RIVERSIDE COUNTY AIRPORT LAND USE COMMISSION

STAFF REPORT

CASE NUMBER: ZAP1026PV22 – Richland Developers, Inc (Representative: Derek Barbour)

JURISDICTION CASE NOS: DPR 22-00002 (Development Plan Review), TPM38446 (Tentative Parcel Map)

Title: MASTER SITE PLAN

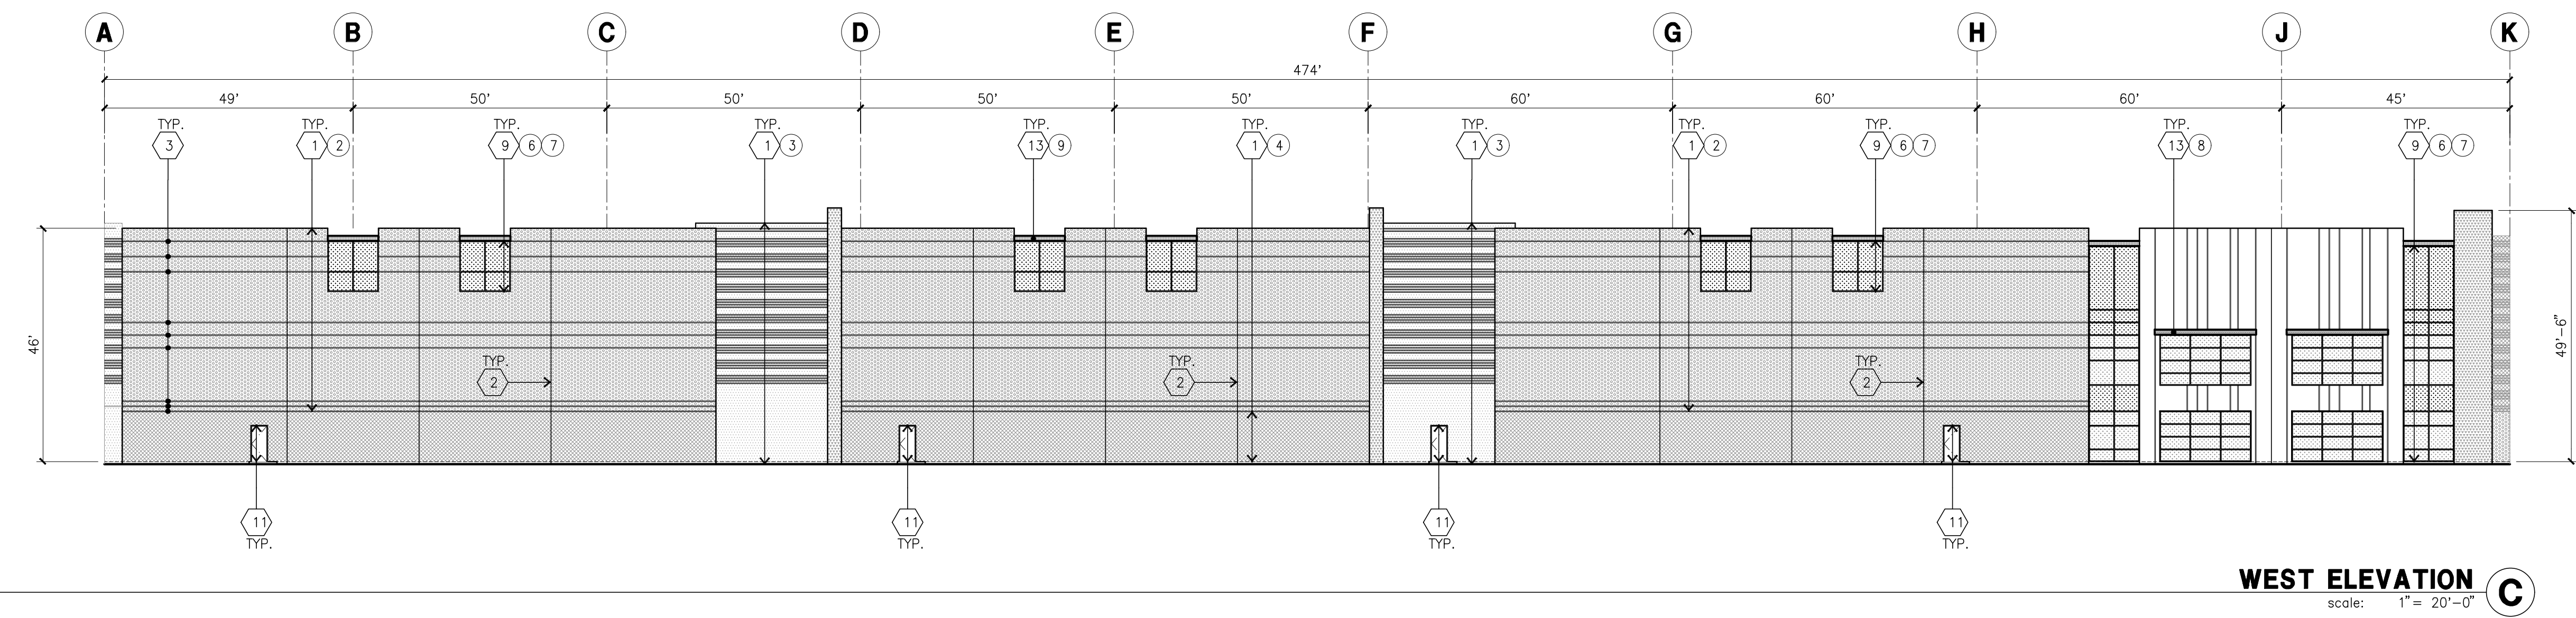
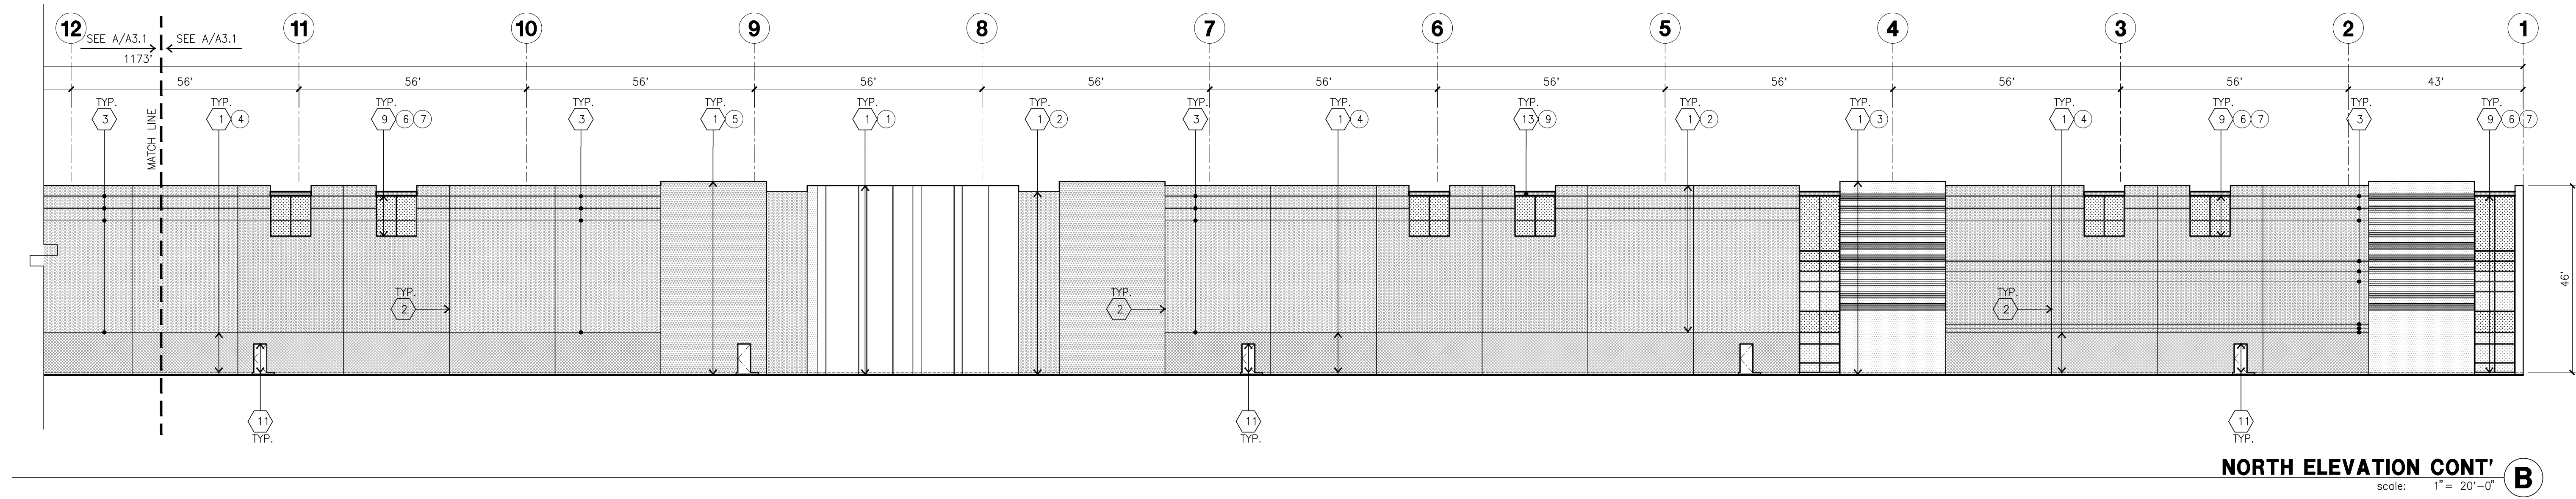
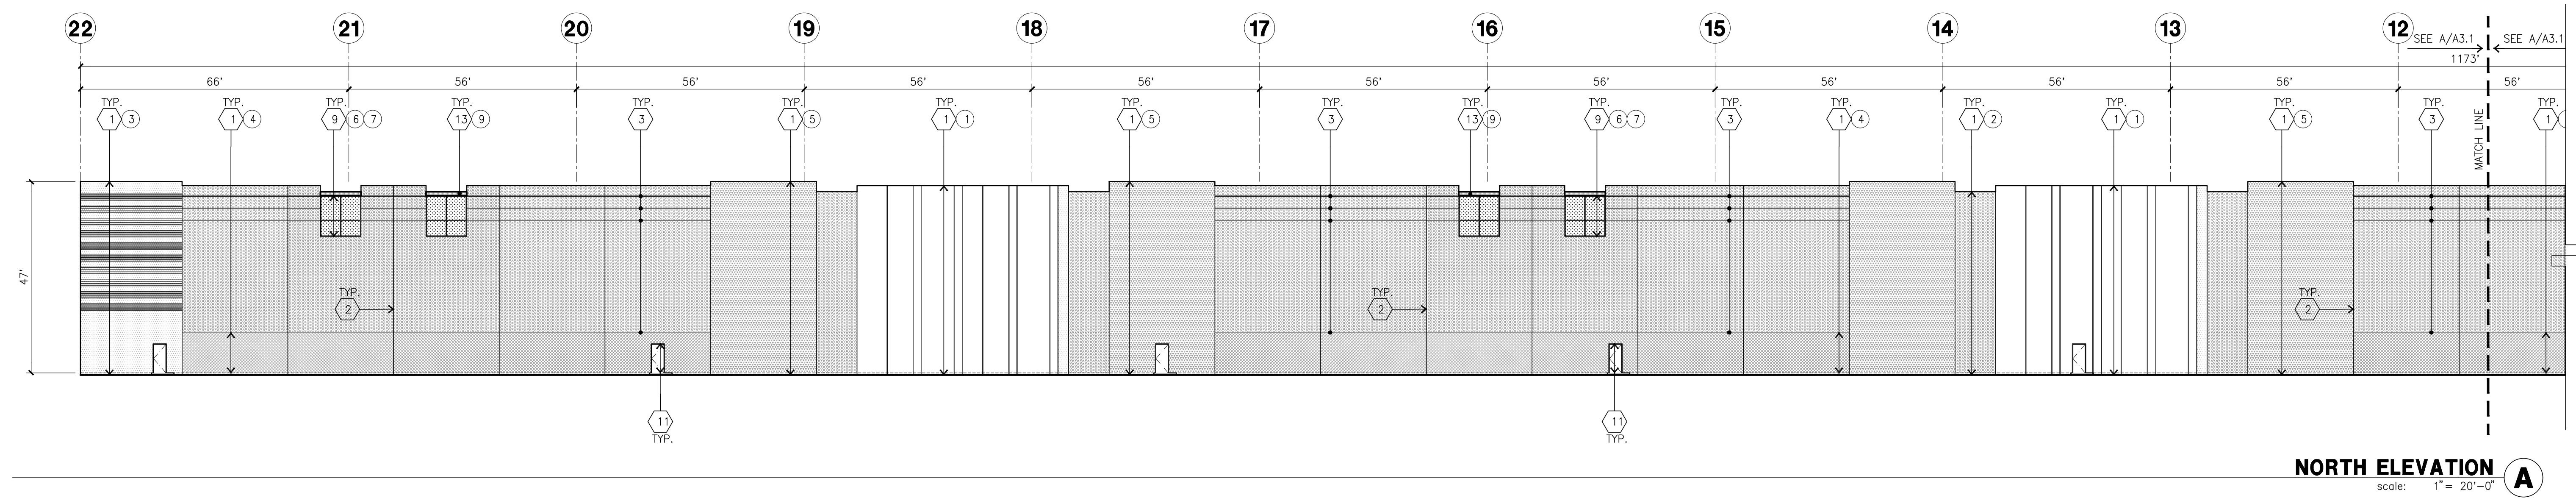
- Ultralight/light sport runway - that the existing ultralight/light sport runway and its traffic pattern would be impacted by the project.

According to the Conasters comments, the ultralight/light sport runway is a dirt runway 930 feet long and 110 feet wide, with the centerline approximately 55 feet east of the westerly property line (shared with the proposed project - the edge of the runway is approximately 110 feet from the nearest point of the proposed building). The runway has been in existence for approximately 40 years. The airport is in the process of updating its Airport Facility Directory to include new striping and runway paving per the adopted 2011 Perris Valley Airport Land Use Compatibility Plan (PVALUCP).

According to the Conasters comments, the height and proximity of the proposed building would impact the skydiving and parachuting operations, more specifically parachuting landing areas. They indicated that mechanical turbulence and thermal activity created by the proposed project would create hazards to the skydiving operations by the change in wind direction and velocities. They estimate an average of approximately 120,000 skydiving jumps a year.

RECOMMENDATION: Staff recommends that the Development Plan Review and Tentative Parcel Map be found **CONDITIONALLY CONSISTENT** with the 2011 Perris Valley Airport Land Use Compatibility Plan and the 2014 March Air Reserve Base/Inland Port Airport Land Use Compatibility Plan, subject to the conditions included herein, and such additional conditions as may be required by the Federal Aviation Administration Obstruction Evaluation Service. *It is also advised that the local jurisdiction during the CEQA process analyze and evaluate the project's impacts on the safety of the existing skydiving/parachuting and ultralight/light sport aircraft operations.*

6. This project has been evaluated as consisting of 10,000 square feet of first floor office area, 10,000 square feet of second floor mezzanine office area, and 630,280 square feet of warehouse area. Any increase in building area, height, change in use to any higher intensity use, change in building location or modification of the tentative parcel map lot lines and areas will require an amended review to evaluate consistency with the ALUCP compatibility criteria, at the discretion of the ALUC Director.
